CAMECO CORPORATION'S REQUEST FOR LICENSE RENEWAL FOR THE BLIND RIVER URANIUM REFINERY

Ref. 2021 – H-09

Northwatch

Presentation to the Canadian Nuclear Safety Commission

Figure 3: Average Soil Uranium Concentrations (regular sampling) -2000, 2002, 2003, 2007

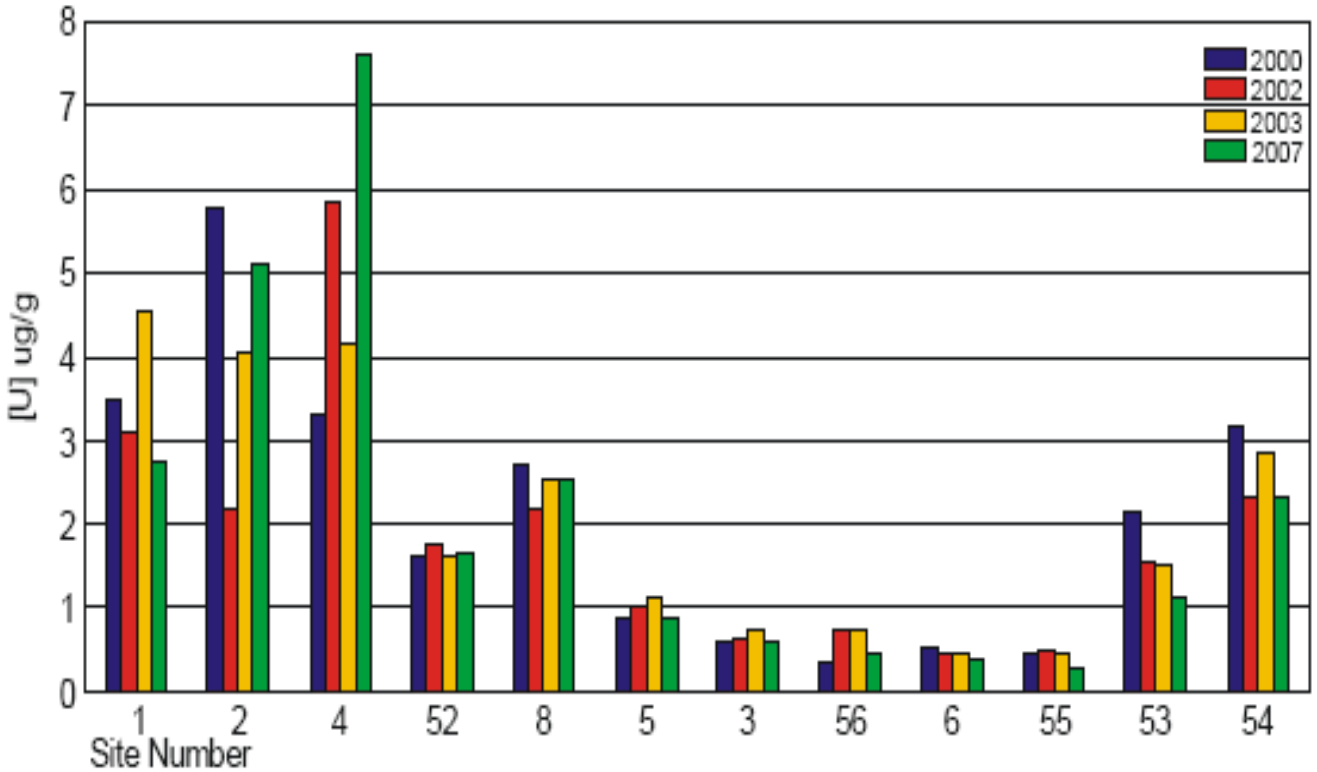
- Of the six sites which were sampled, four of the sites showed increases from the sample averages of 2007. Of those four sites, Sites 2 and 4 sampling results in 2007 had in turn indicated increases from the 2003 sampling results. These two sites also showed the most significant increase of uranium concentrations, with averages increased by close to 150% and 100% respectively. Two sites – Sites 1 and 8 – showed slight decreases in average concentrations of uranium in the soil samples.
